Access Compliance Report

Public Rights-of-Way

Intersection ID: 47087	Main Street: MARVIN_RD	Cross Street: COVENTRY_COURT_LN	Location: SW
ADA ID: 90D3D0BE178C	Ramp Type: Perp	Initial Pass/Fail: Pass	Overall Compliance: No
			Severity Score: 15

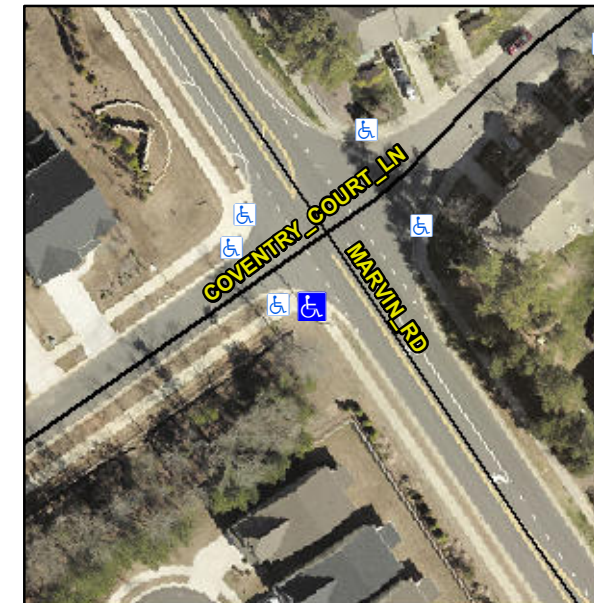
Possible Solutions:

Install Landing. Remove & Replace Gutter.

R304.2.1, R304.2.2-Perp, R304.3.2-Para, R304.5.3, R304.5.4
